Re: Rezoning request for Wieuca Road Church Property

On August 16, the NBCA Zoning Committee (“Committee”) approved a motion to support the rezoning request for the Wieuca Road Church property subject to a Conditions List and to a revised site plan, attached as Attachment A and Attachment B respectively. On August 31, the NPU-B Zoning Committee approved the rezoning request subject to the same conditions and site plan revisions. This matter will be on the NPU-B Board agenda on September 7. As it prepares to review this rezoning request, this memorandum is to provide the NPU-B Board with the NBCA Zoning Committee’s reasoning on this matter that underlies its approval of the rezoning request and the related Conditions List and revised site plan. This seems appropriate for such a large rezoning request that will have major impacts.

Wieuca Road Church Rezoning Request NBCA Review Process

Attachment B

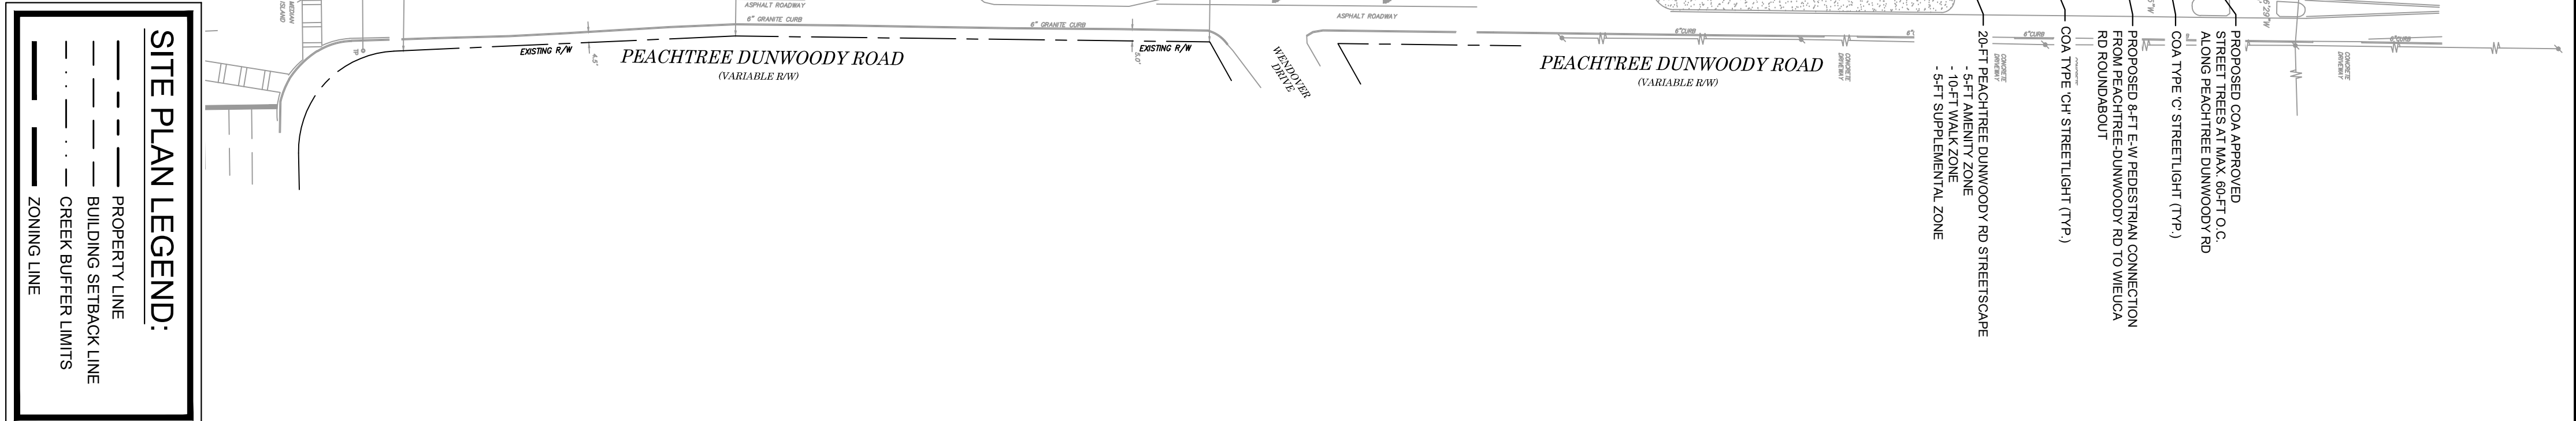
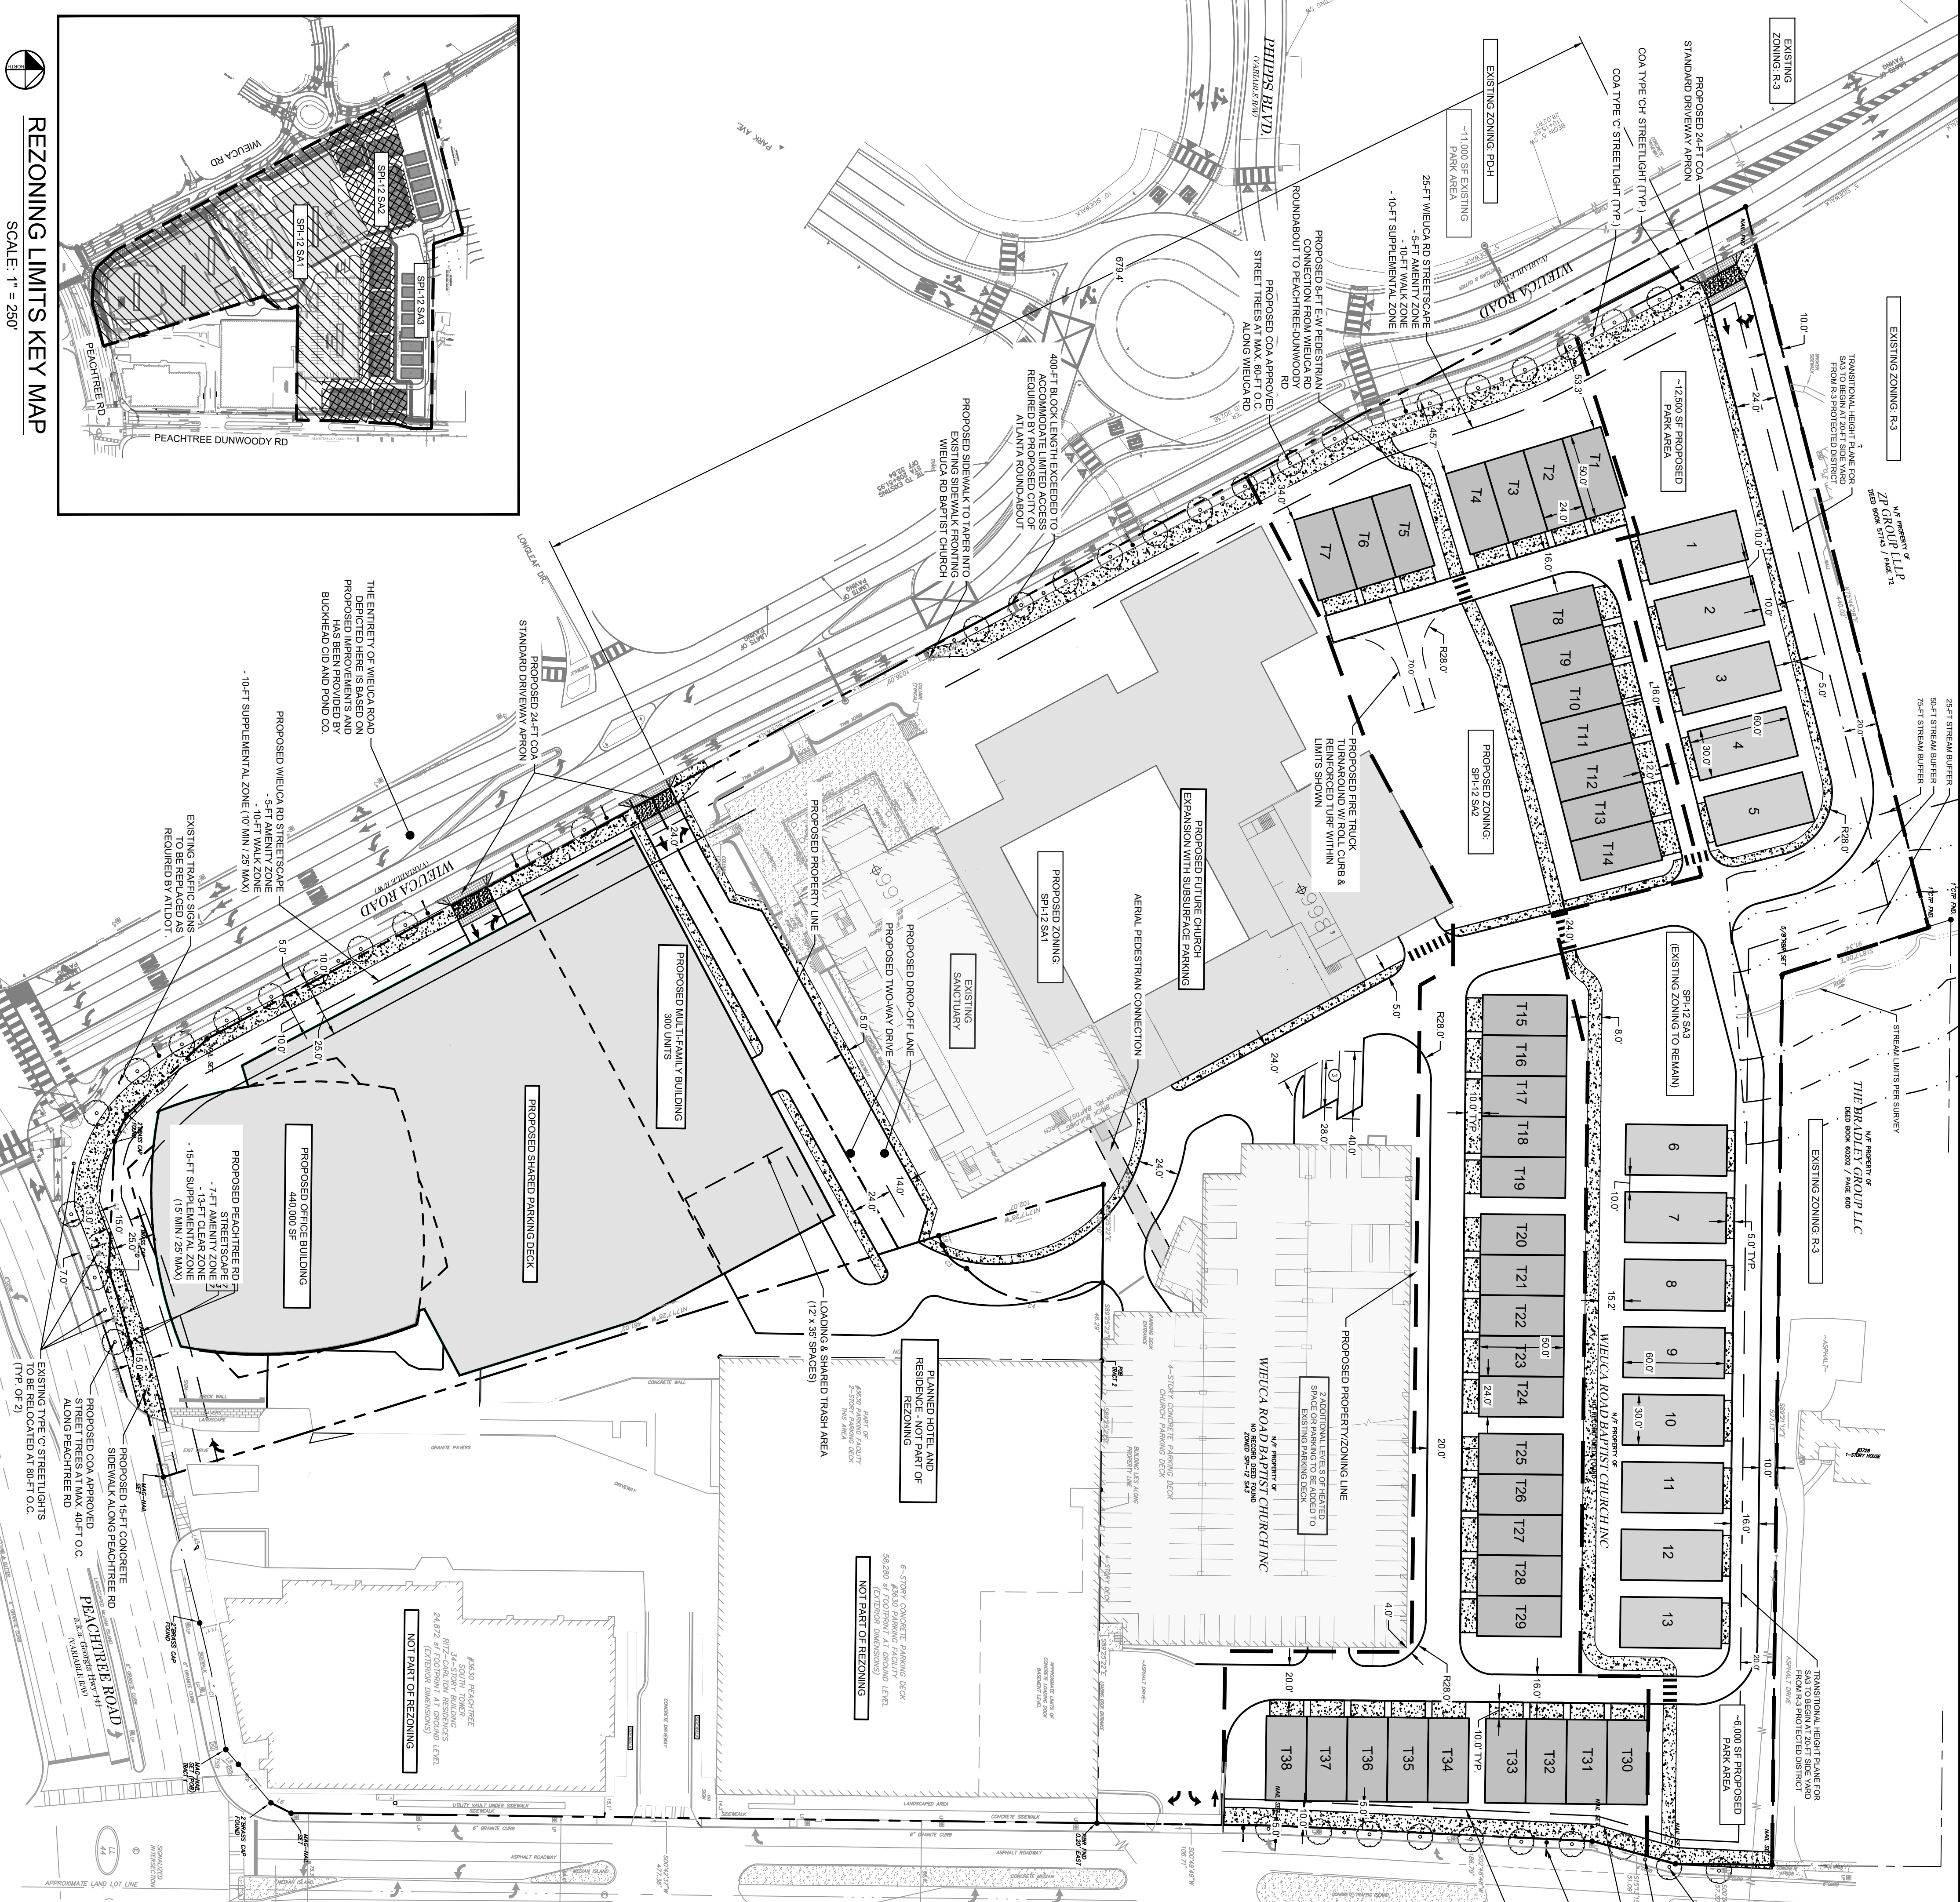
3. Pull development back from Wieuca and Peachtree-Dunwoody: At the northern end of the site, the original site plan showed townhouses fronting directly on the sidewalks, creating an urban feel just as the project is transitioning into a R-3 neighborhood. We successfully sought to have the townhouses pulled back from the sidewalks on both Wieuca and Peachtree Dunwoody. This creates a much more comfortable transition to North Buckhead's single-family neighborhood. Combined with the existing North Buckhead Park across Wieuca, this creates an attractive "gateway" to North Buckhead. (See Attachment D)

4. Add greenspace: In this same northern area, in addition to pulling the townhouses back from the sidewalk, the revised site plan adds a 12,500 SF greenspace on Wieuca Road and a 6,000 SF greenspace on Peachtree Dunwoody Road. The revised site plan retained an attractive pedestrian walkway through the residential area, connecting Wieuca and Peachtree Dunwoody. All the greenspace and walkways are public amenities, allowing North Buckhead residents to much more easily connect on foot or bike between Wieuca and Peachtree Dunwoody. (See Condition 28 and Attachment D.) As public amenities, the Committee also required that the developer install video surveillance cameras and connect these with the City's Video Integration Center (See Condition 18).

2. The property shall be developed in accordance with the site plan and uses entitled "Wieuca, 3626, 3693 and 3715 Wieuca Road and 3714 Peachtree Dunwoody Road" prepared by Kimley Horn and Associates, Inc. dated August 16, 2021 and marked received by the City of Atlanta Office of Zoning and Development 8/20/2021.
